REDBUD H&H HOMES

PLAN REVISIONS

BUYER MARKED

REDBUD - GARAGE LEFT
H&H HOMES

FRONT ELEVATION 'A'

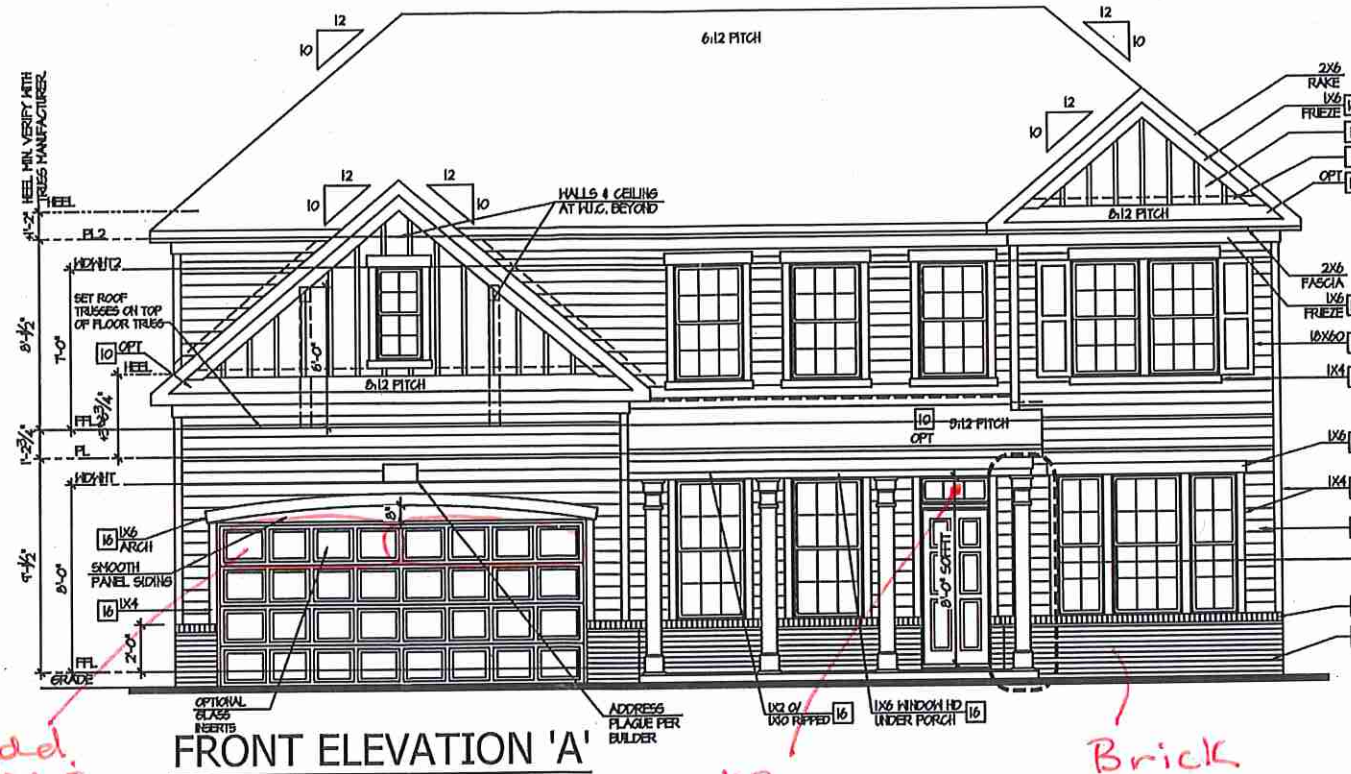
add glass + hardware

no guide

1ST FLOOR PLAN 'A'

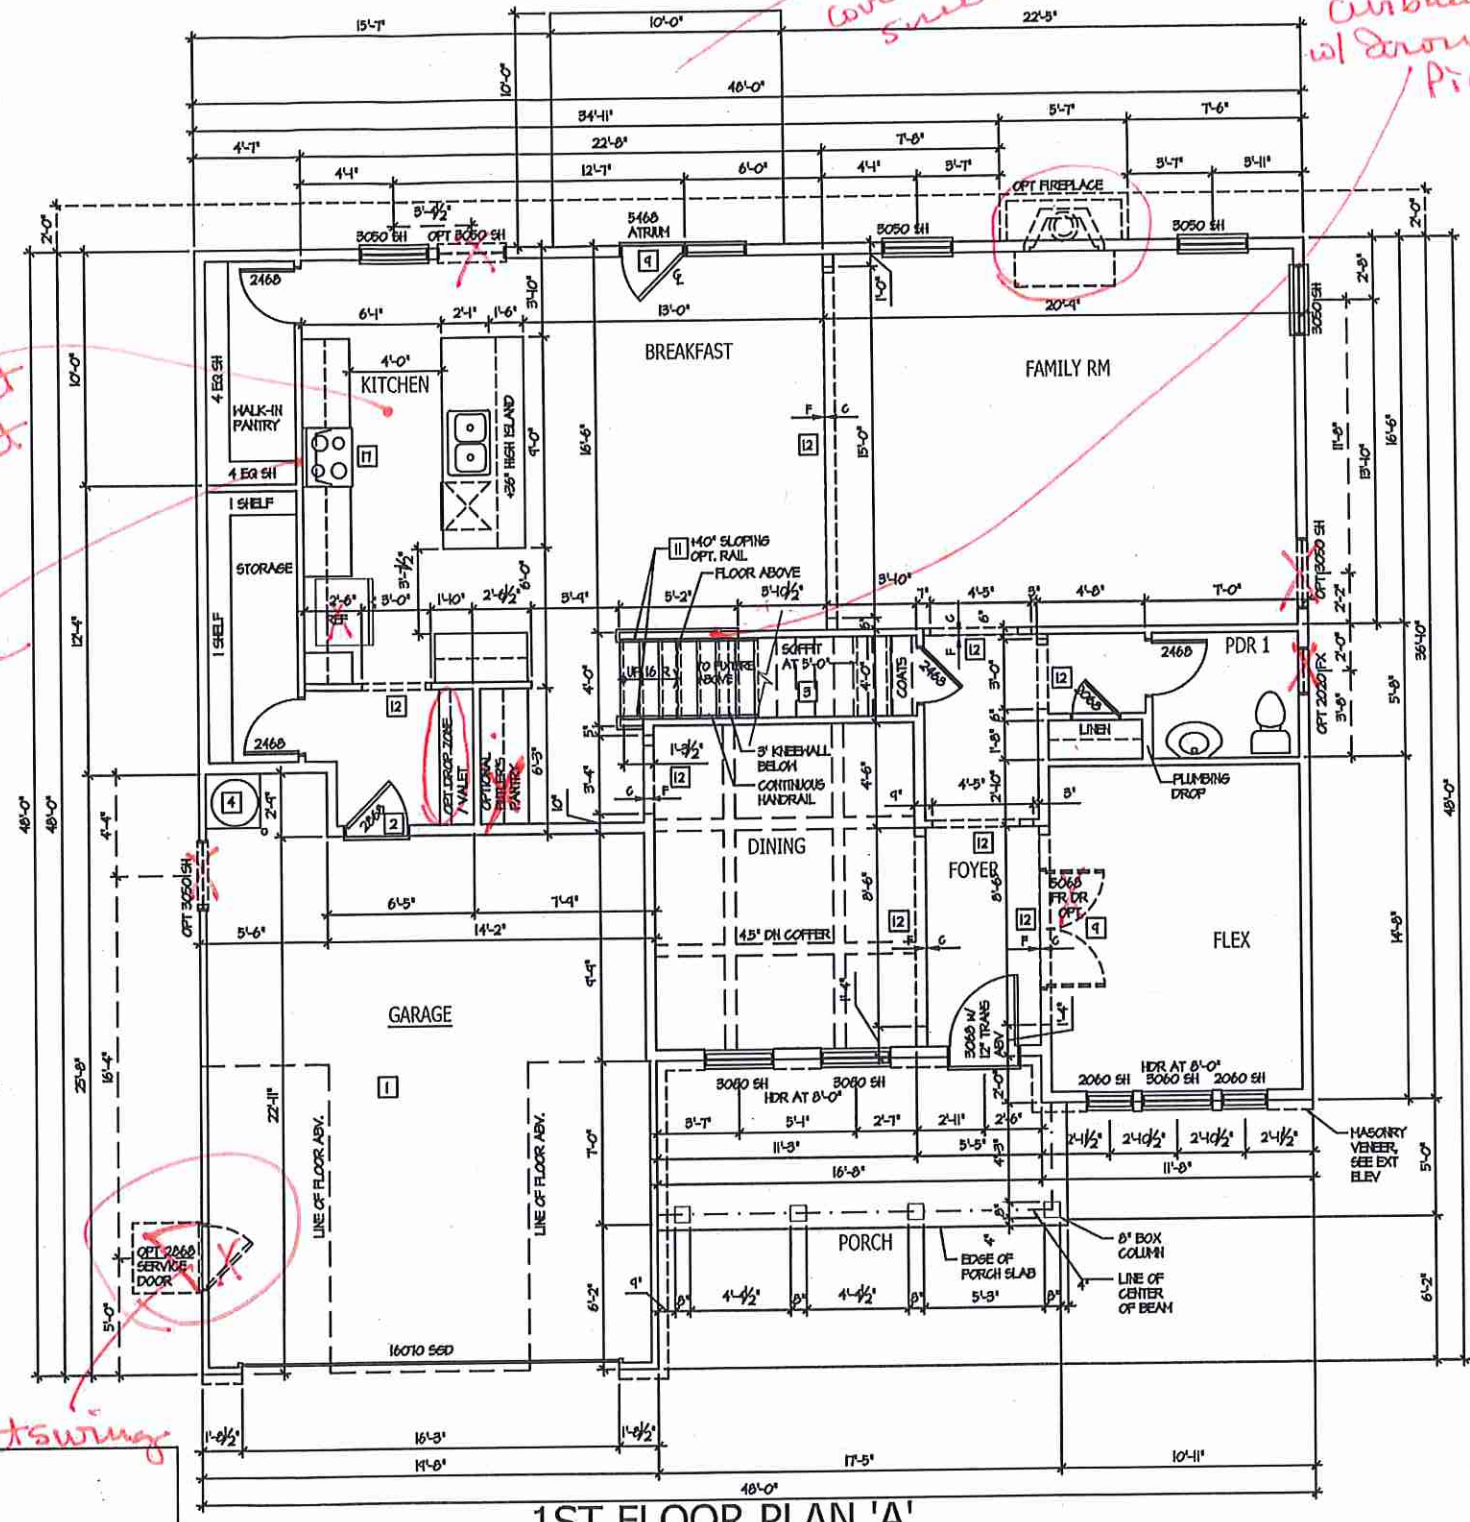
*see gourmet layout
opt line*

see covered screened porch
curbwall w/ down pickets

MAIN FLOOR ELECTRICAL PLAN 'A'

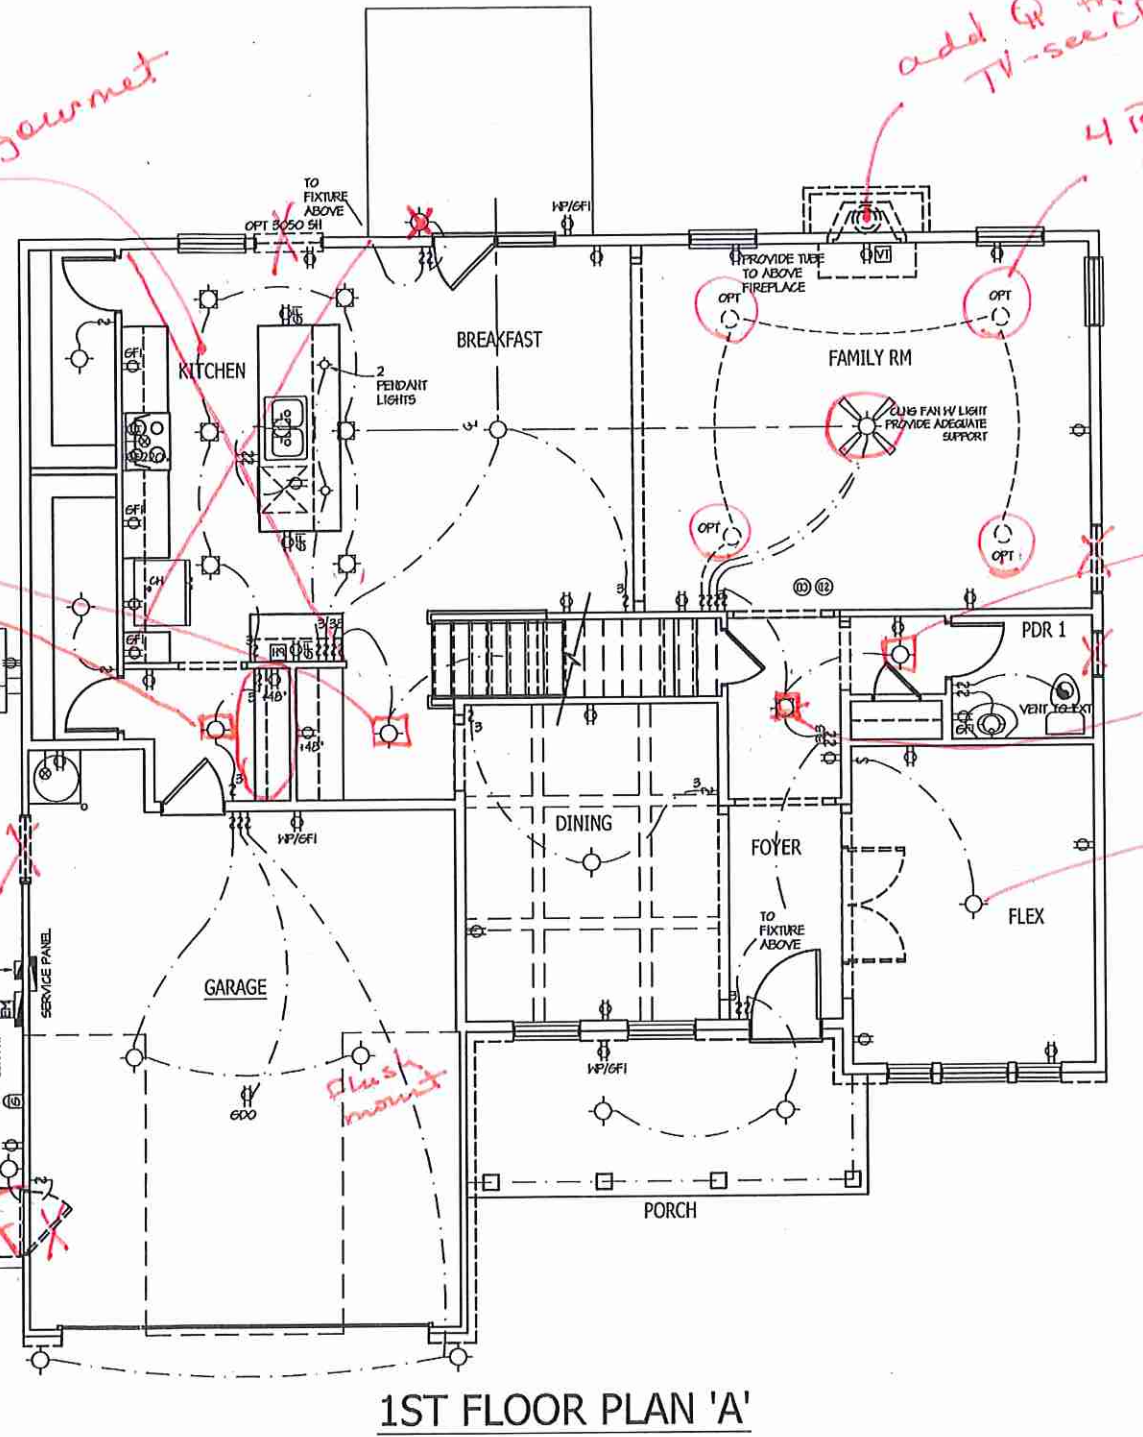
see gourmet

*add @ for TV - see CPE plan
4 Recessed cans w/ Dimmer*

Recessed can

provide for ceiling fan

flush mount

out swing

2ND FLOOR PLAN 'A'

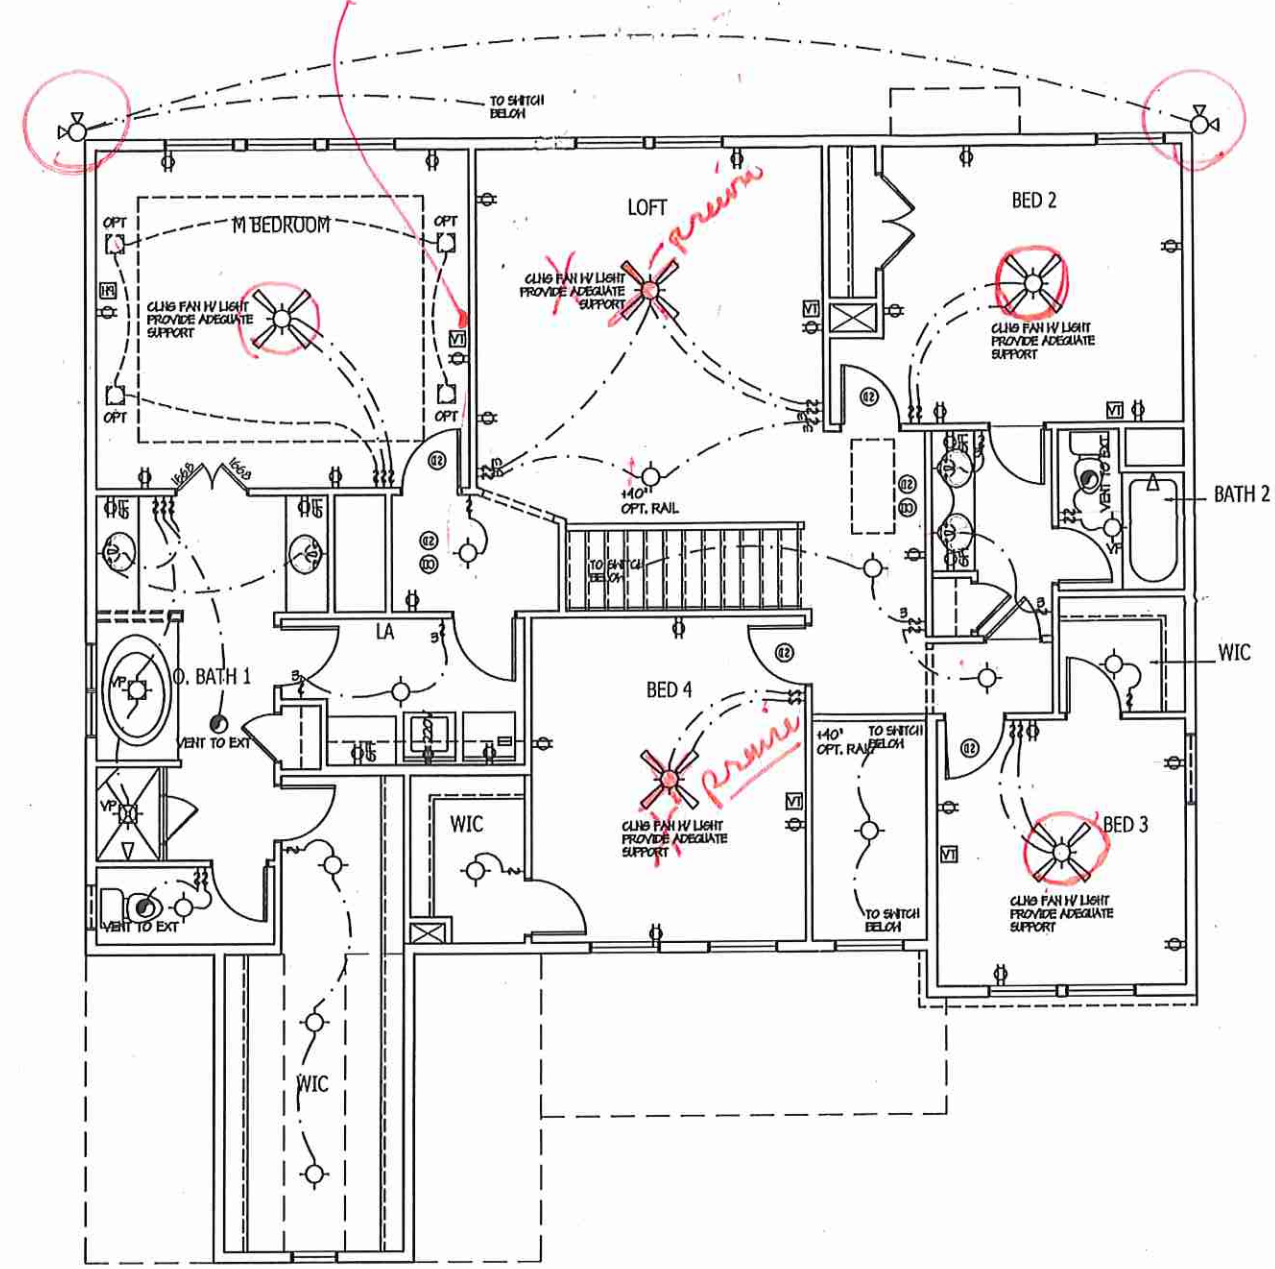
add @ 55" fr TV
